Re: Docket No. 08-AFC-07C
GWF Tracy Combined Cycle Power Plant

On behalf of GWF Energy LLC (“GWF”), and pursuant to your request, attached please find a revised version of Addendum No. 1 to Cultural Resources Assessment, Installation of Temporary Storage Tanks, in Support of Petition to Amend (TN Number: 206941).

Addendum No. 1 to Cultural Resources Assessment for GWF Tracy Combined Cycle Power Plant (08-AFC-7C); GWF Energy LLC Installation of Temporary Storage Tanks in Support of Petition to Amend

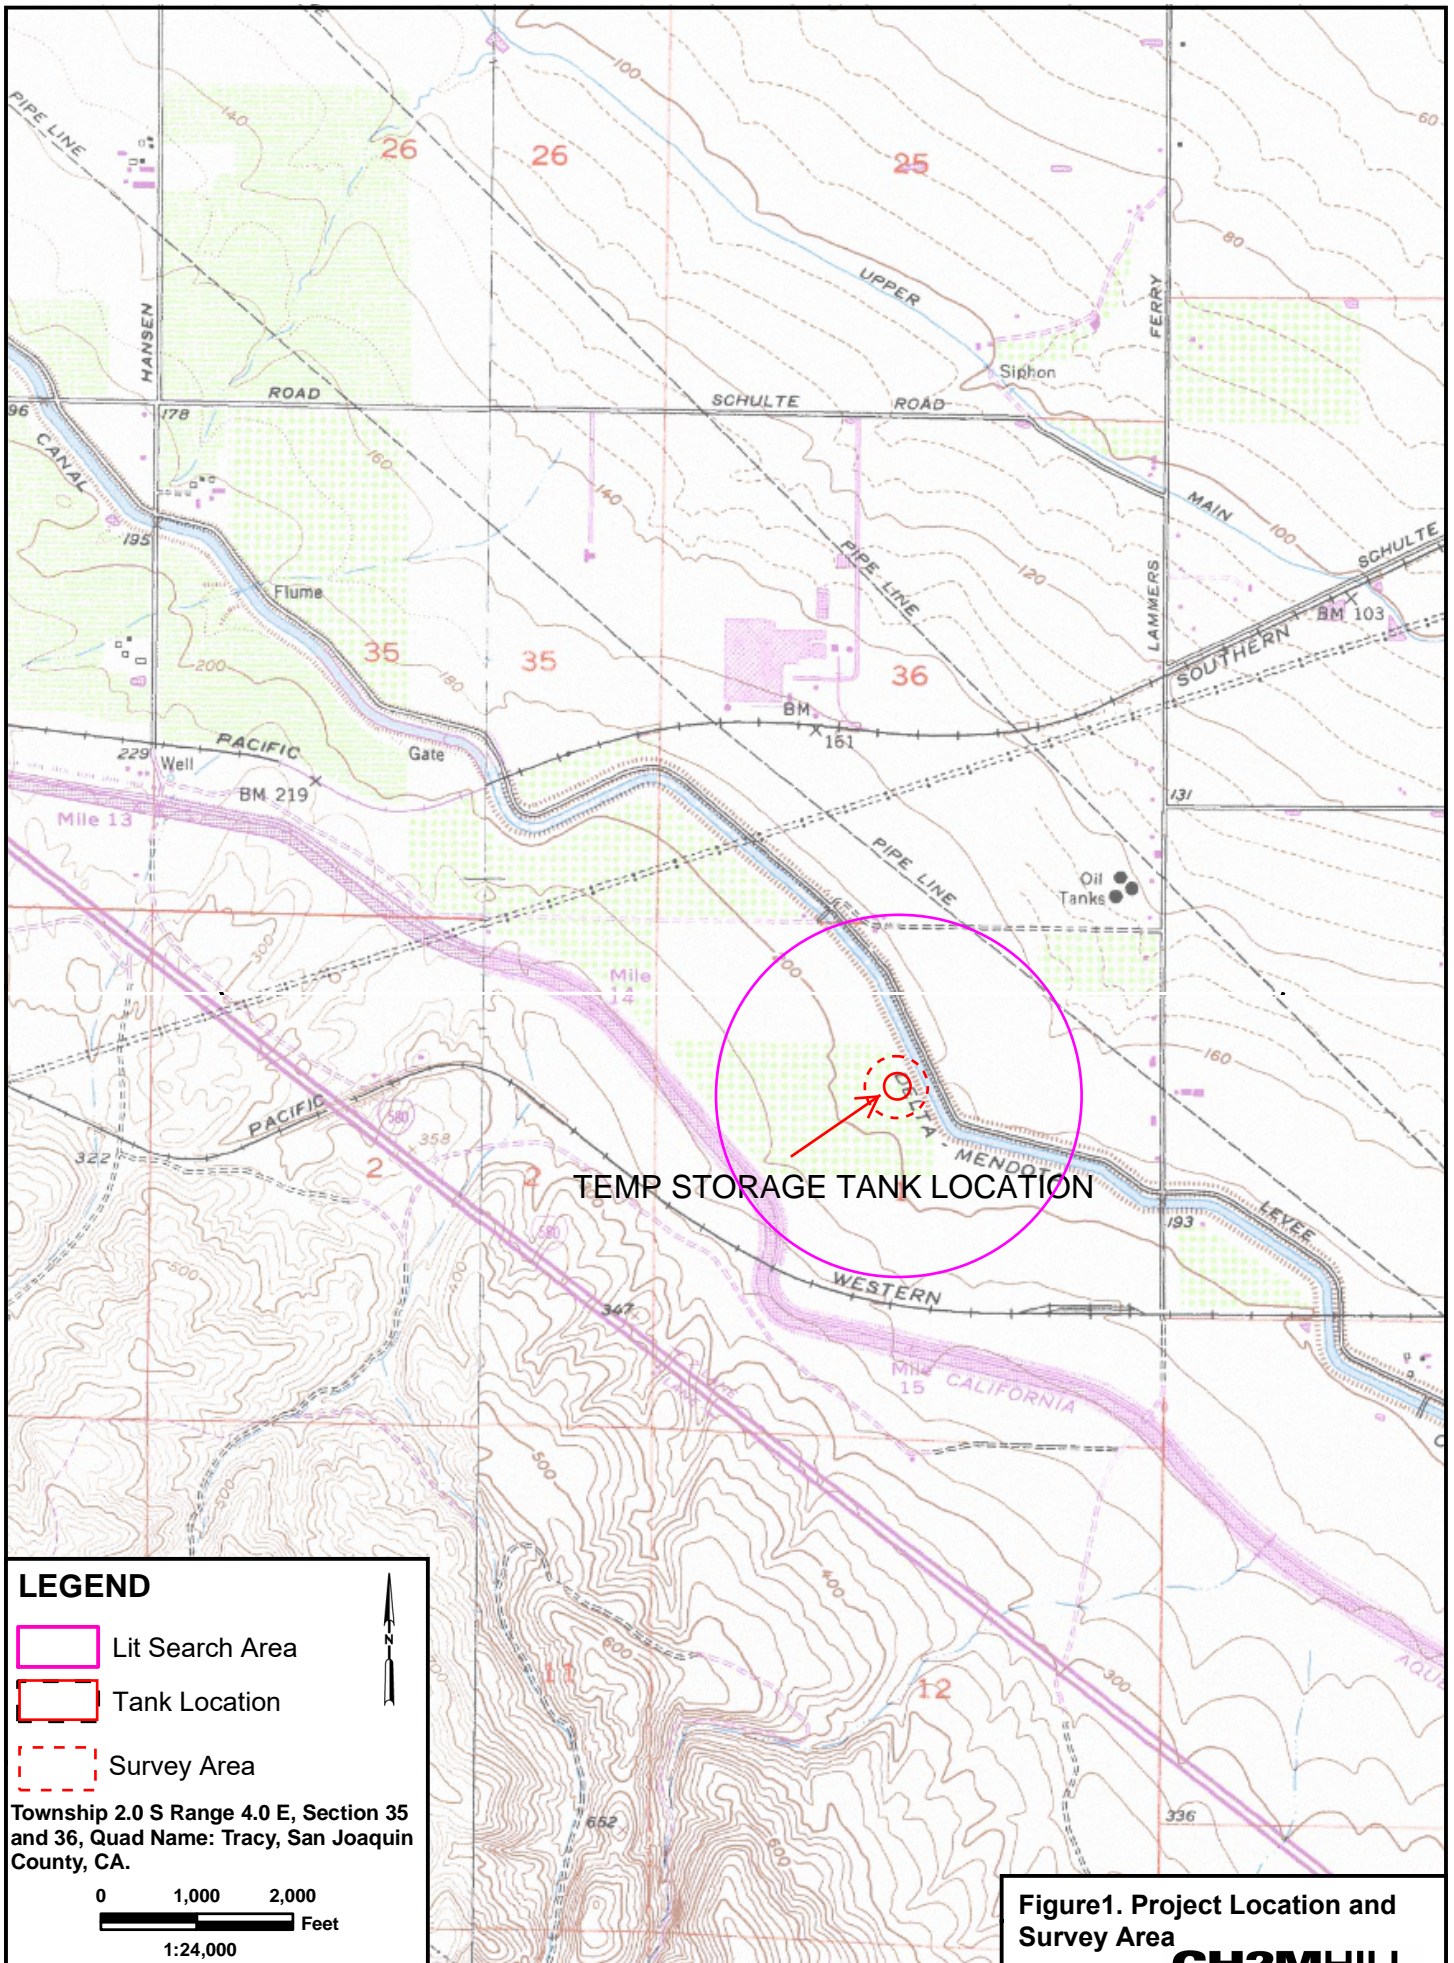
1. Revised Figure 1 to show the location of the offsite temporary water storage area that Dr. Fitzgerald surveyed; and
2. Corrected legend item referenced above.
